General Bid Bulletin No. 15
16 July 2021

**THE MALOLOS-CLARK RAILWAY PROJECT AND THE NORTH-SOUTH RAILWAY
PROJECT SOUTH LINE COMMUTER PACKAGE CP NS-01: PROCUREMENT OF
ELECTRICAL AND MECHANICAL SYSTEMS AND TRACK WORKS (IFB No: 21-040-3)**

PACKAGE CP NS-01: E&M SYSTEMS AND TRACK WORKS
General Bid Bulletin No. 15
Annex A

PACKAGE CP NS-01: E&M SYSTEMS AND TRACK WORKS
General Bid Bulletin No. 15
Annex B

MALOLOS - CLARK RAILWAY PROJECT (MCRP) NORTH SOUTH RAILWAY PROJECT-SOUTH (NSRP-SOUTH)
Package CP NS-01 : Bidding Documents
SUBSTATION LAYOUT (SS No. S21)

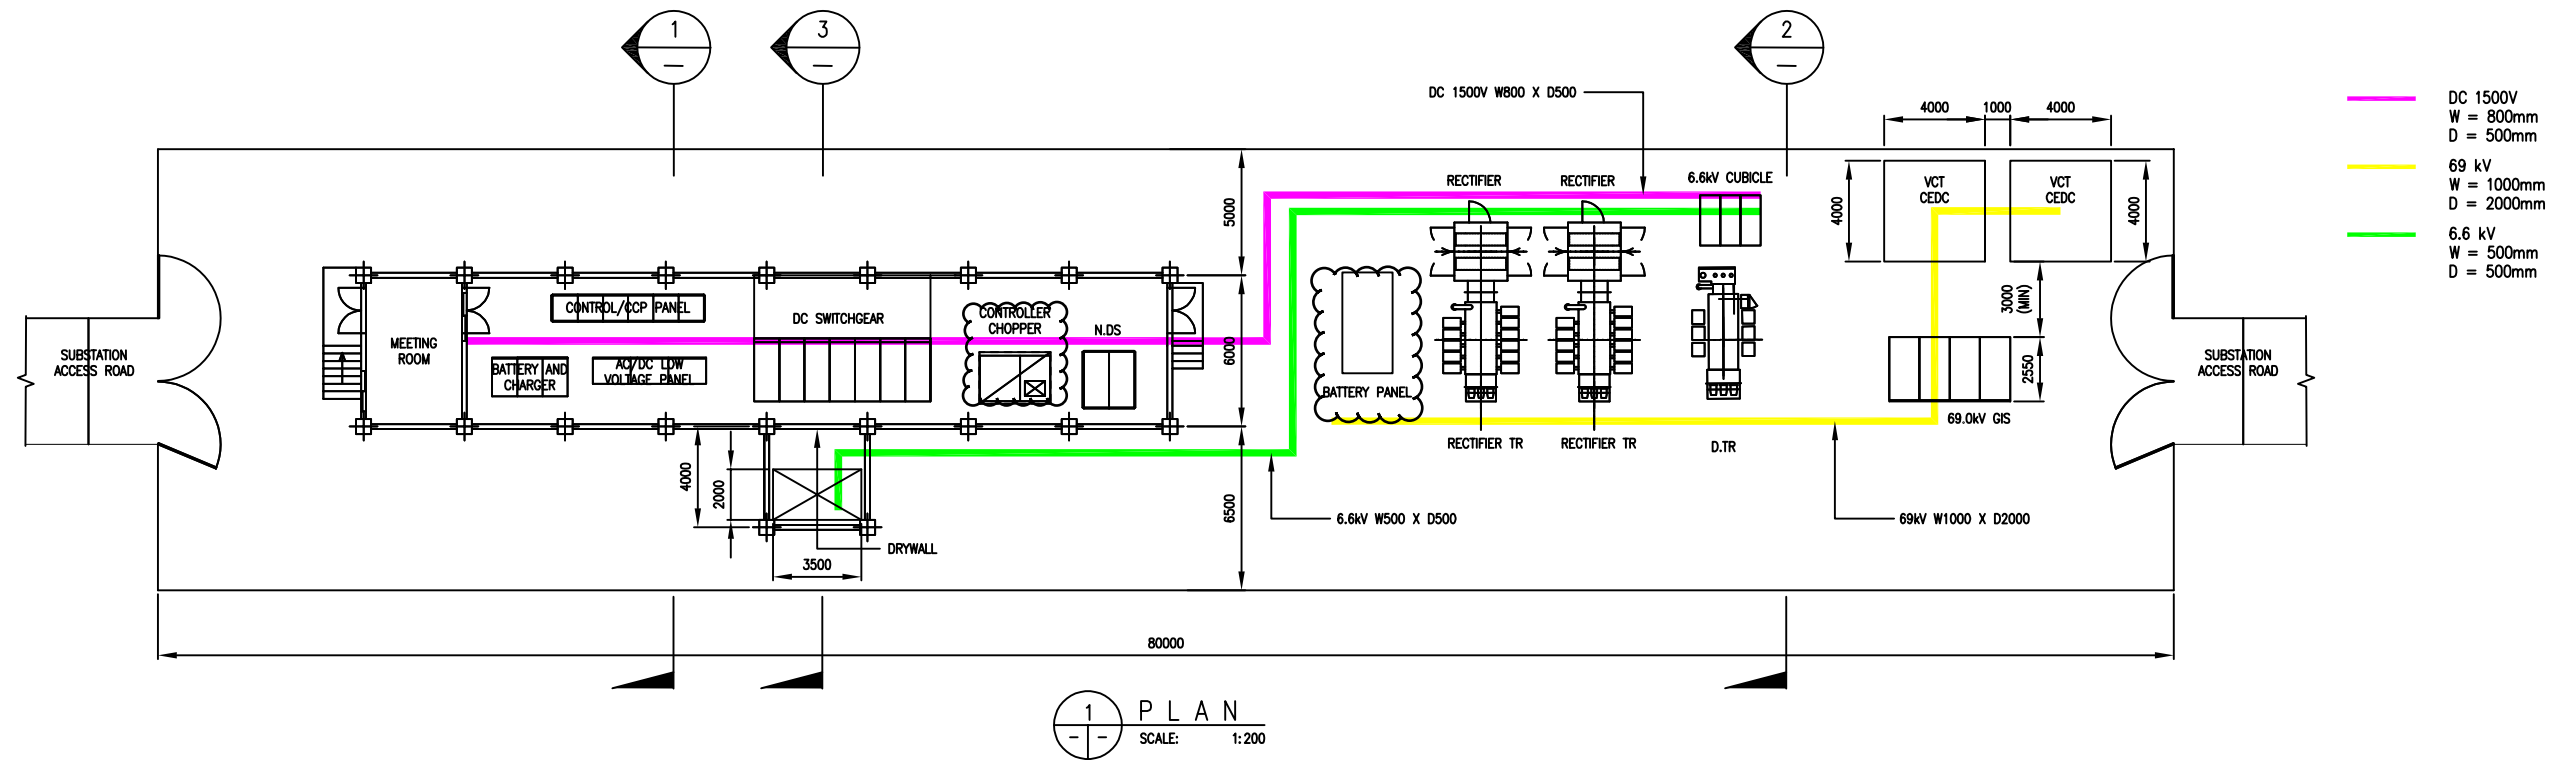
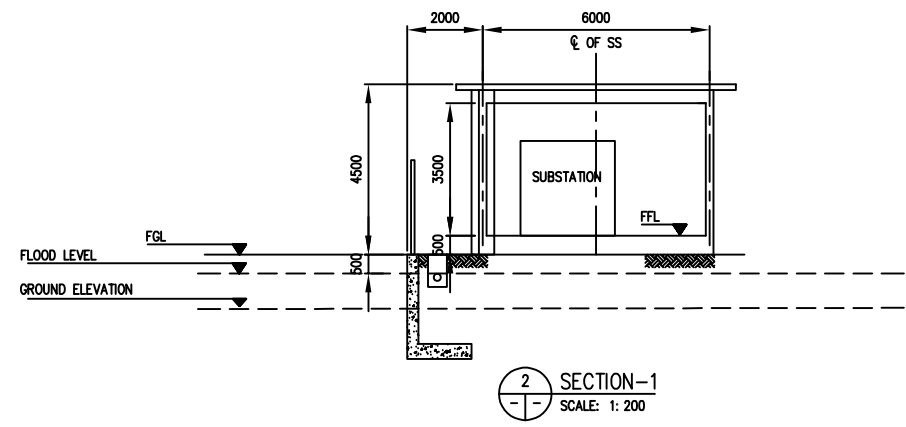
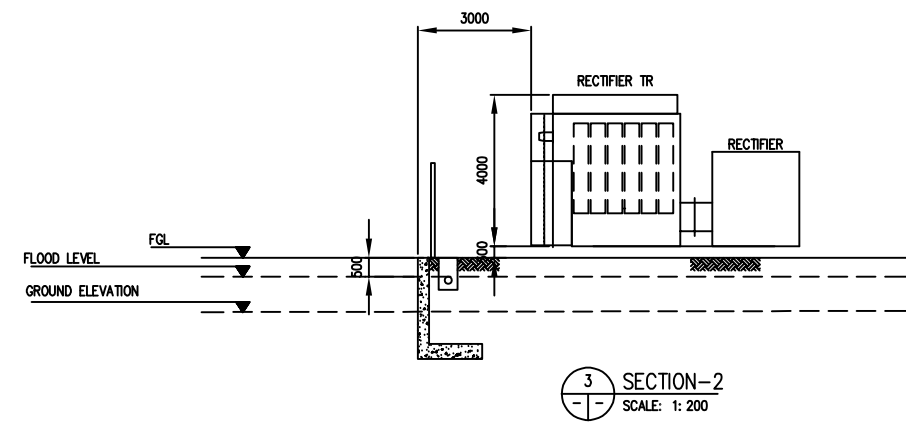
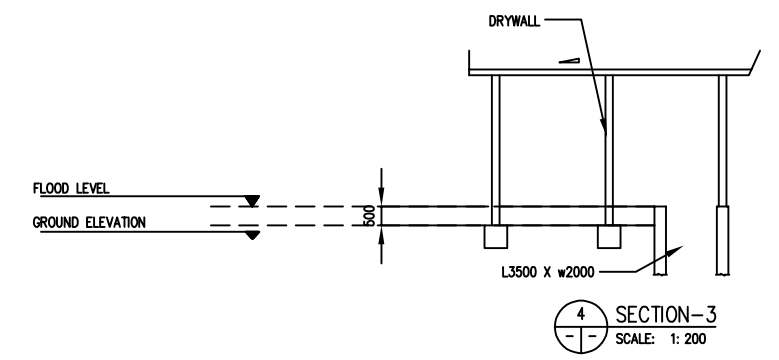
Volume III Part 2 – Employer’s Requirements d) Employer’s Drawings		
7	Part 2 Vol.3 E_M Version 11.0 FINAL Rev. A. ERD (a) page 164	Revised Traction Power Feeding System Drawing
8	GBB-9 Annex B, Item No.16	Substation Layout Drawings (SS No. 10) to (SS No. 22) “Local Annunciator Panel Added”

VERSIONS	DATE	DESCRIPTION
00	02 MAR 2021	ISSUED FOR REFERENCE
01	09 JUN 2021	RESISTOR CHANGED TO BATTERY POST
02	21 JUN 2021	LOCAL ANNUNCIATOR PANEL ADDED

⊕ SUBSTATION CONNECTION (SS DEPOT)
SCALE: NTS

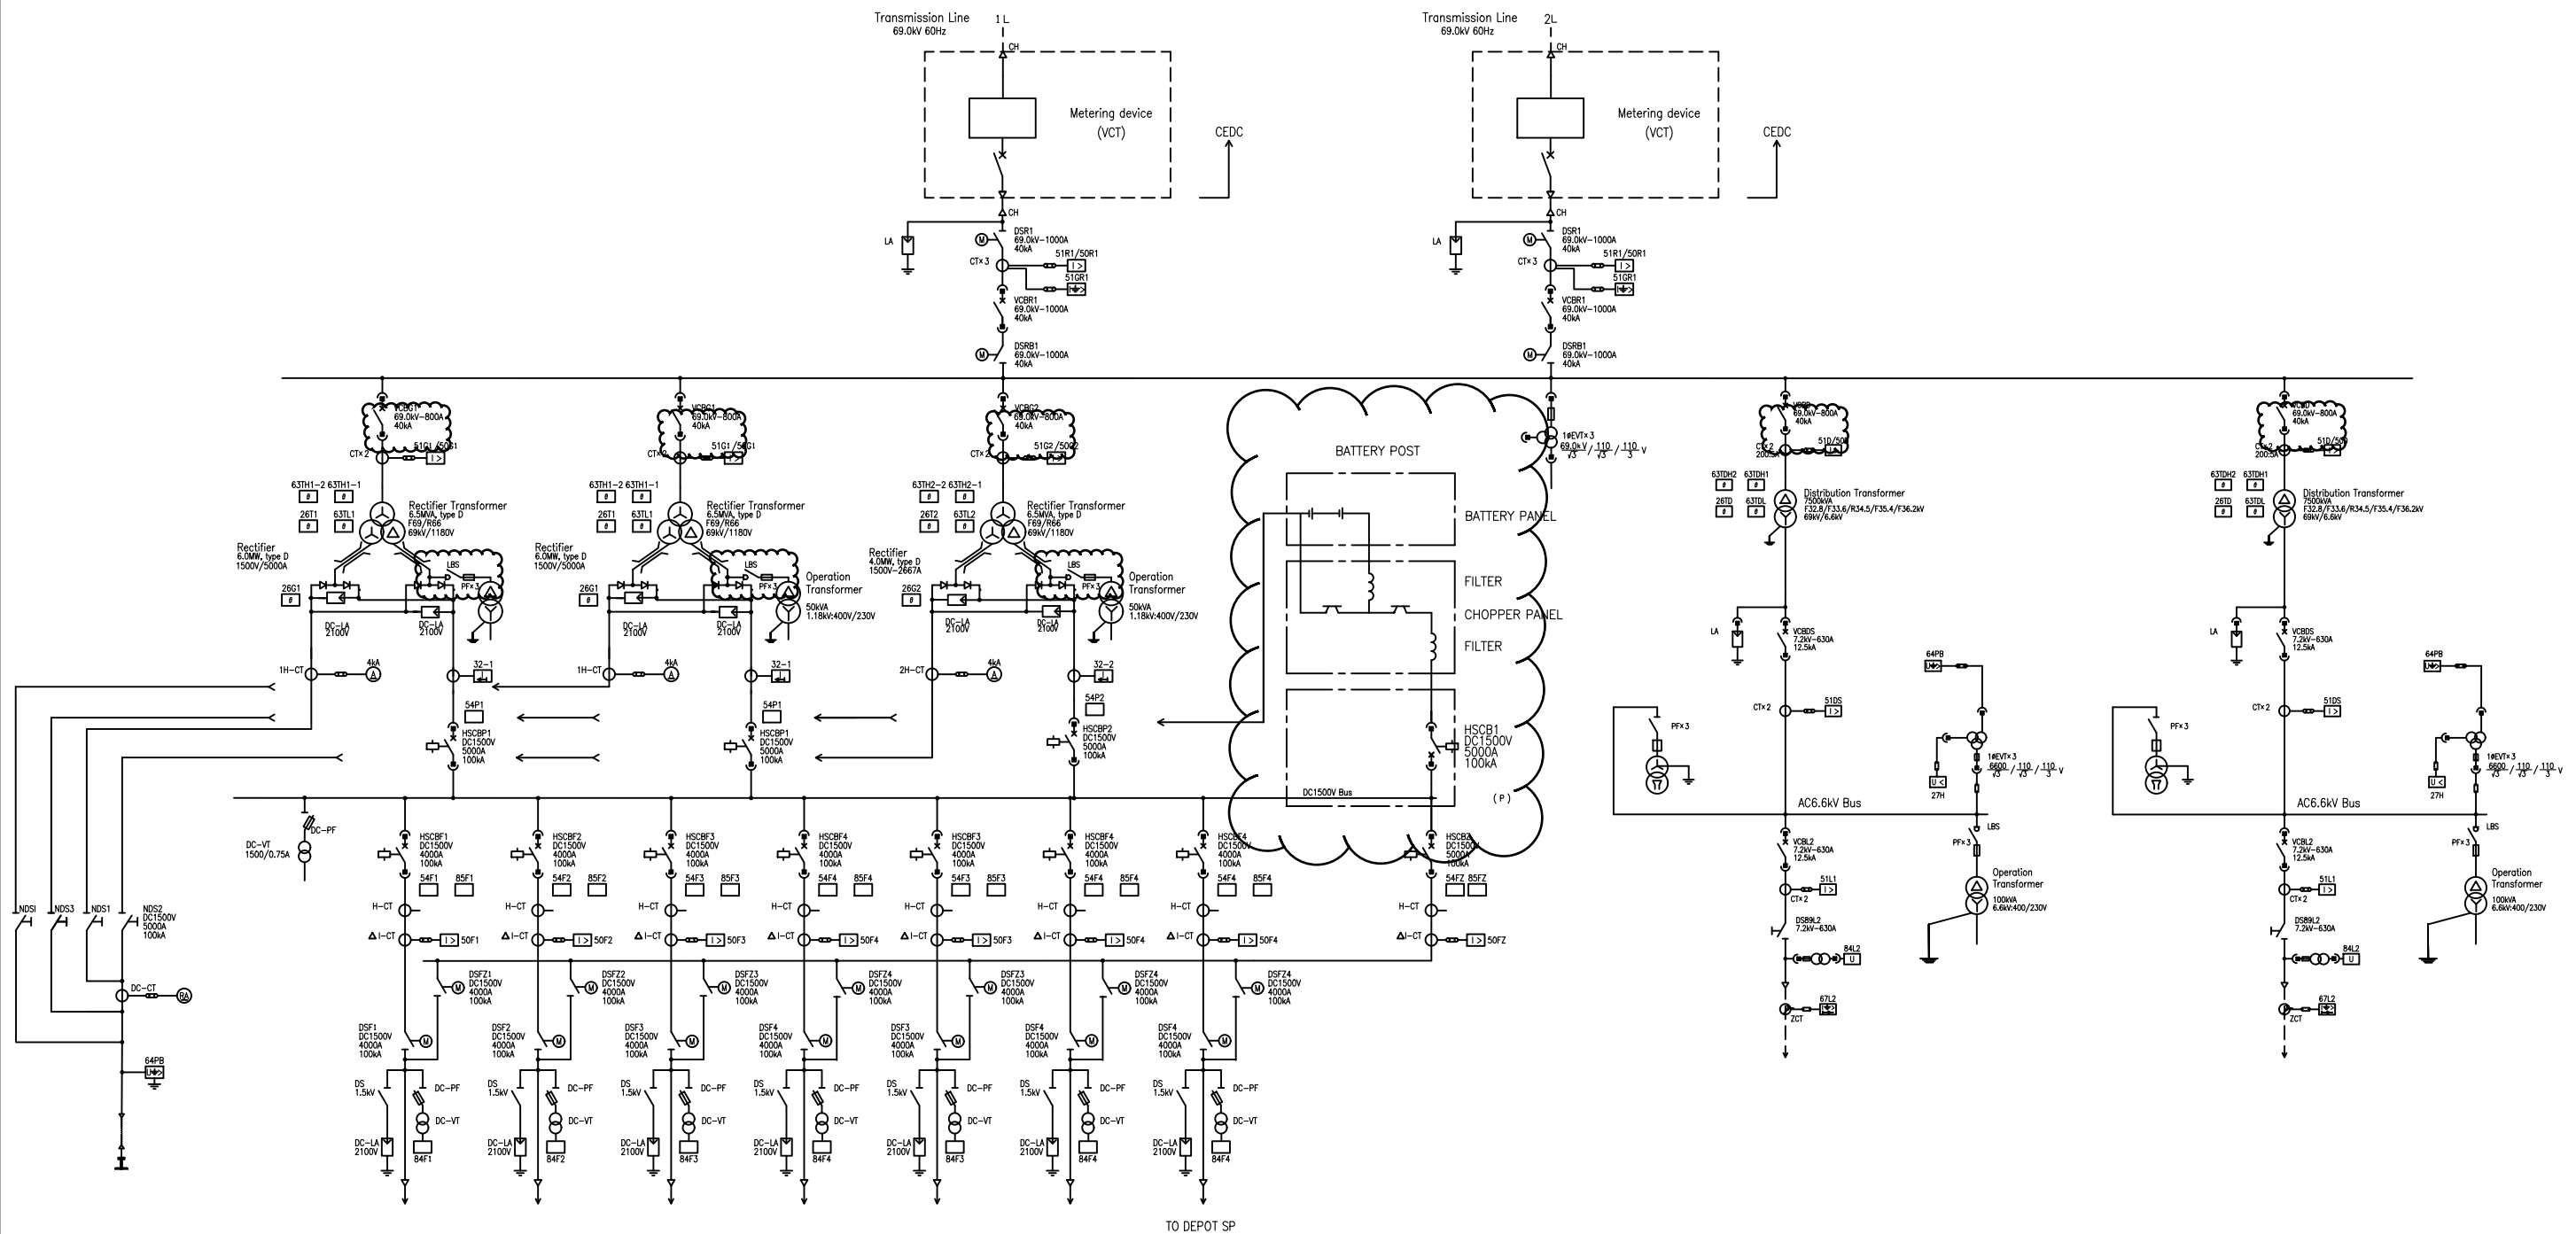
9	Part 2 Vol.3 E_M Version 11.0 FINAL Rev. A. ERD (a) page 194	Revised drawing Substation Connection (SS DEPOT)
10	Part 2 Vol.3 E_M Version 11.0 FINAL Rev. A. ERD (a) page 234	Revised drawing: 6.6kV Power Supply Schematic Diagram 1/2
11	Part 2 Vol.3 E_M Version 11.0 FINAL Rev. A. ERD (a) page 235	Revised drawing: 6.6kV Power Supply Schematic Diagram 2/2

6.6kV POWER SUPPLY SCHEMATIC DIAGRAM
 1/2

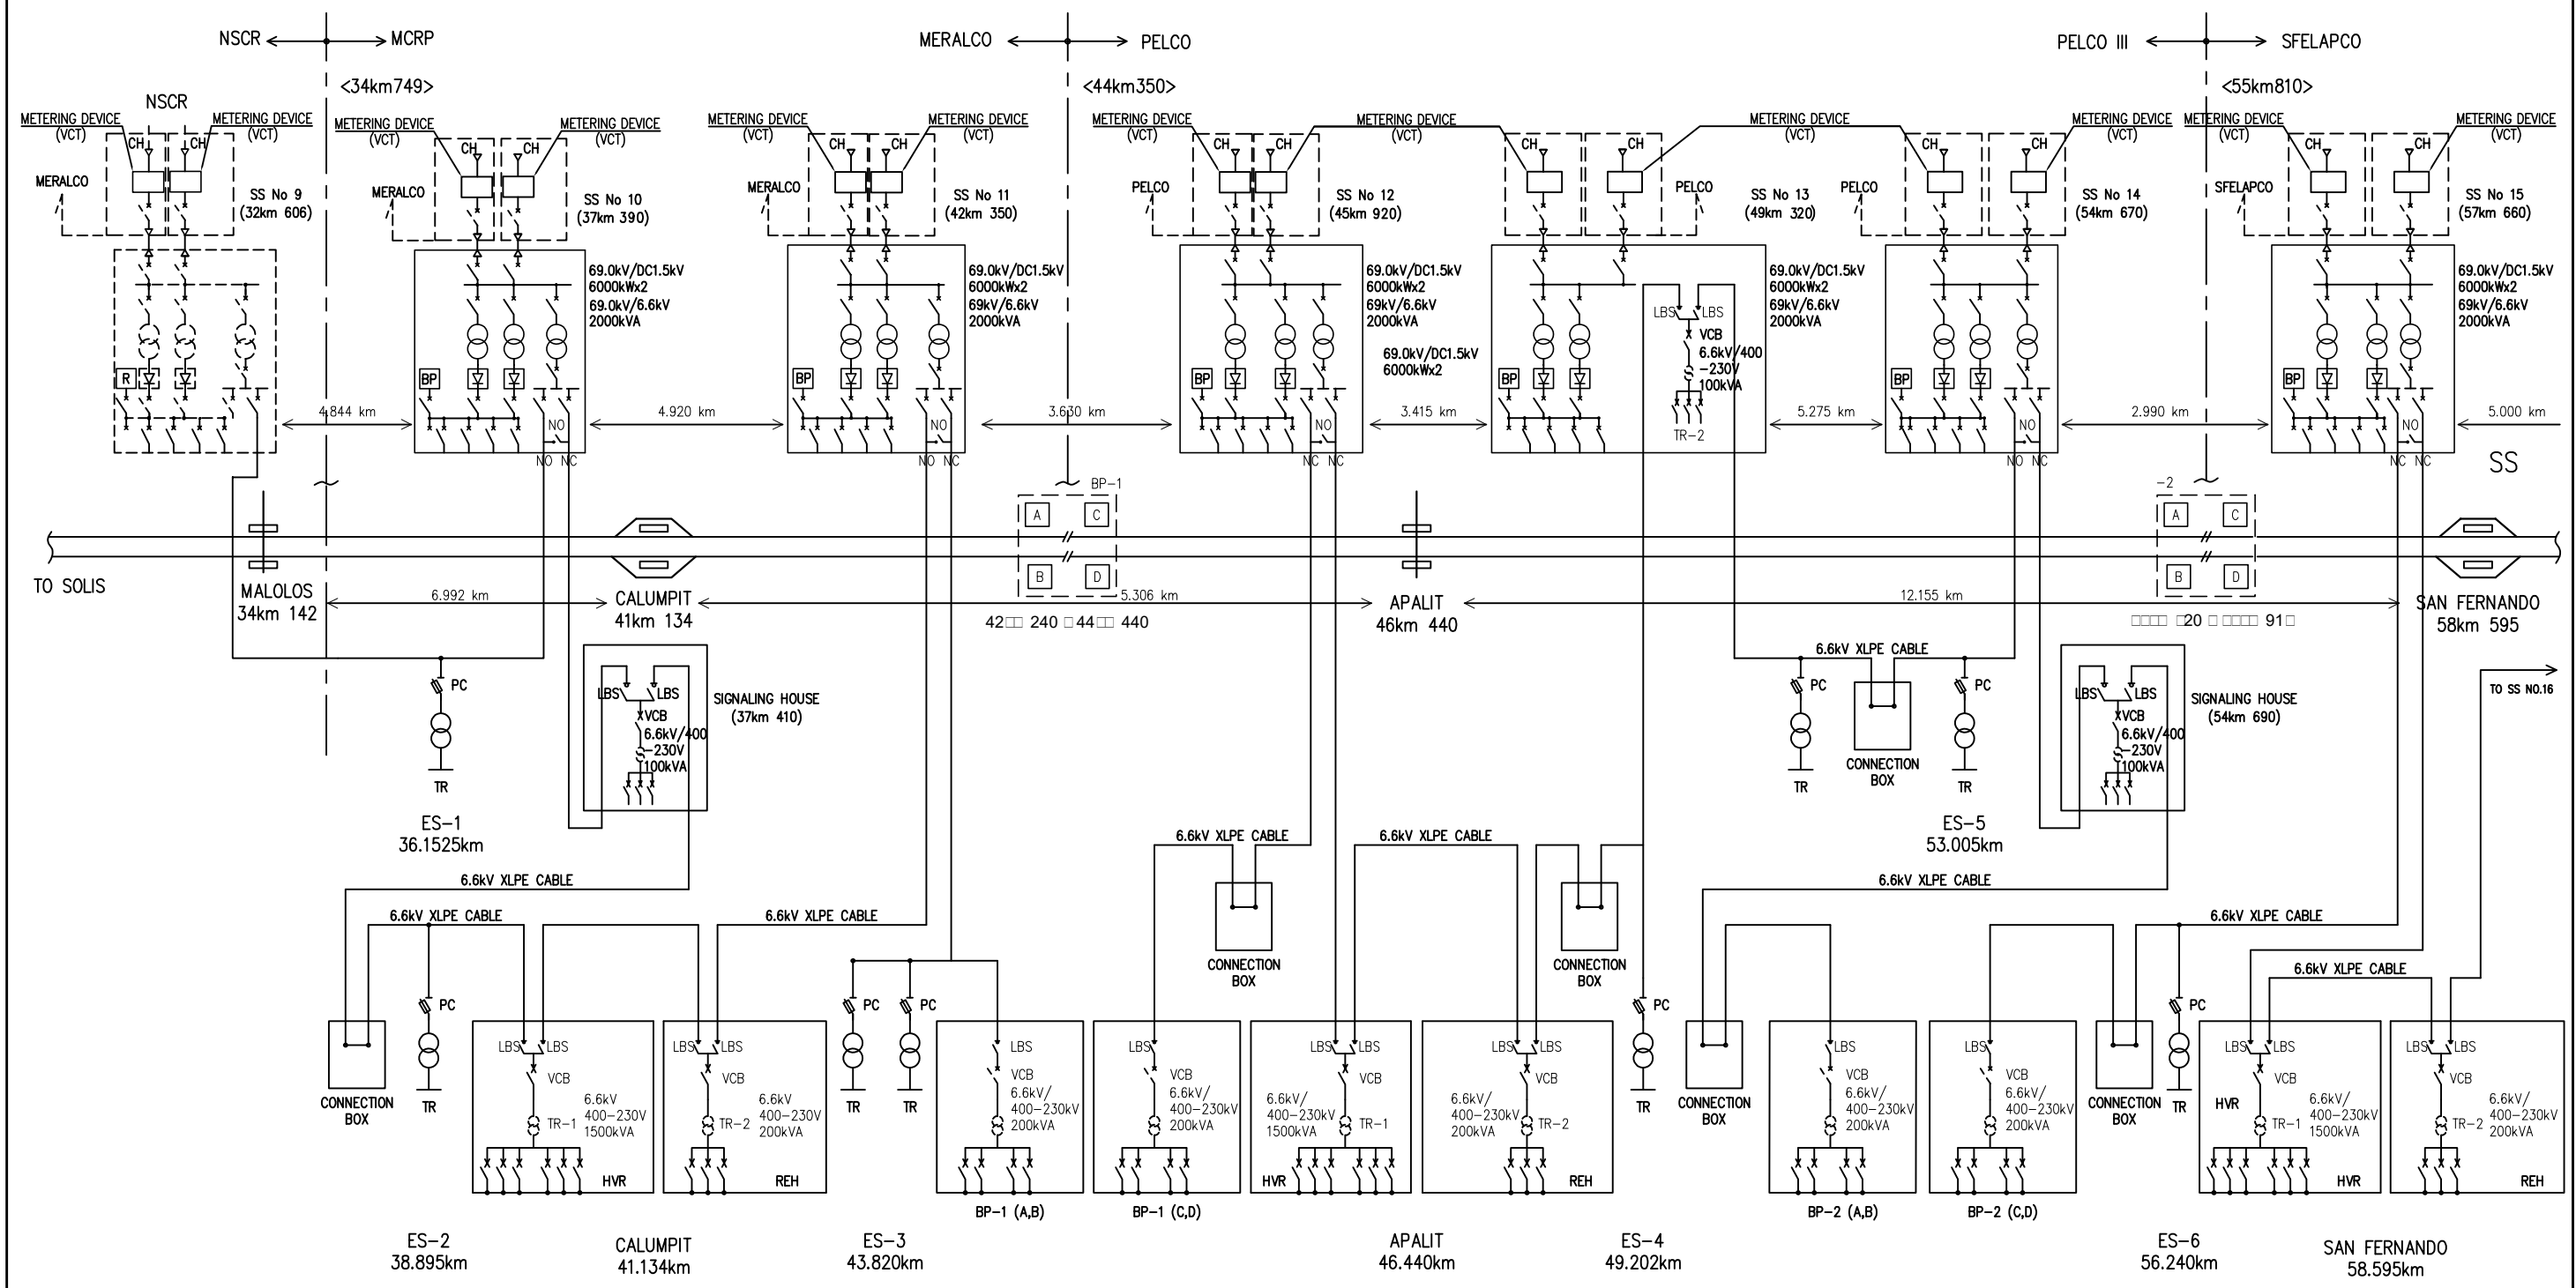
VERSIONS	DATE	DESCRIPTION
01	10 NOV 2020	CABLE BET EEN SS NO 9 TO SS 10 ADDED
02	02 MAR 2021	ISSUED FOR REFERENCE
03	24 JUN 2021	RESISTOR CHANGED TO BP SS NO 10 TO SS NO 11 CHAINAGE REVISID
